REQUEST FOR BIDDING INTERPRETATION (RFBI)

Project No.: 3540SRAEUCO0182
Project Name: Parkfield Fire Station Facility Replacement
Location: 70331 Vineyard Canyon Road, Parkfield, California

Drawing Reference: CG101, CG102, LS101 Project Manual Reference: _____

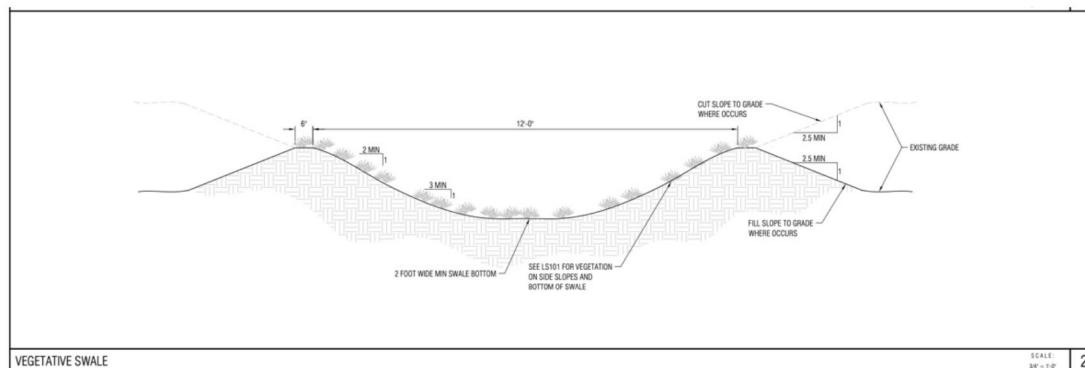
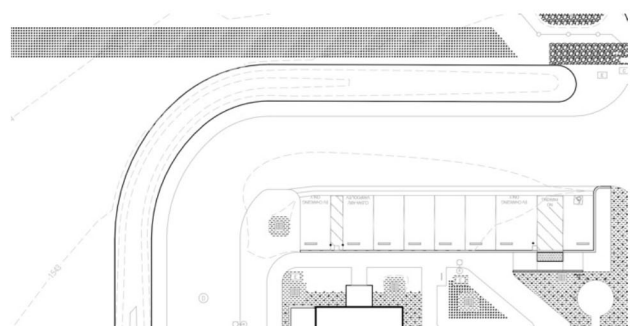
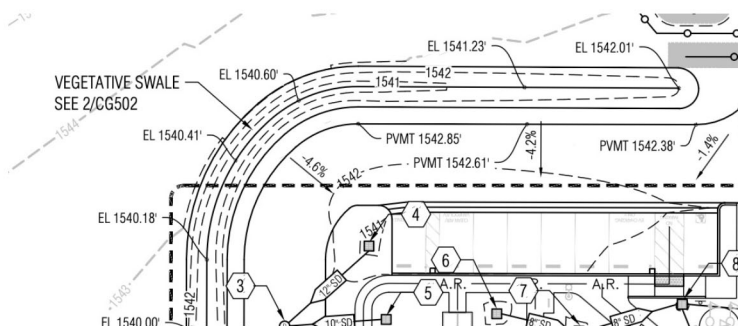
The civil plans show a "vegetated swale" per detail 2 on CG502, but there is no indication or note on the landscape plans about that. See screenshots below. What should we assume in this area?

This area was intended to be hatched with hatching for "One sided blue grass or similar...". Assume this area to have the grasses on side slopes and bottom of swale.
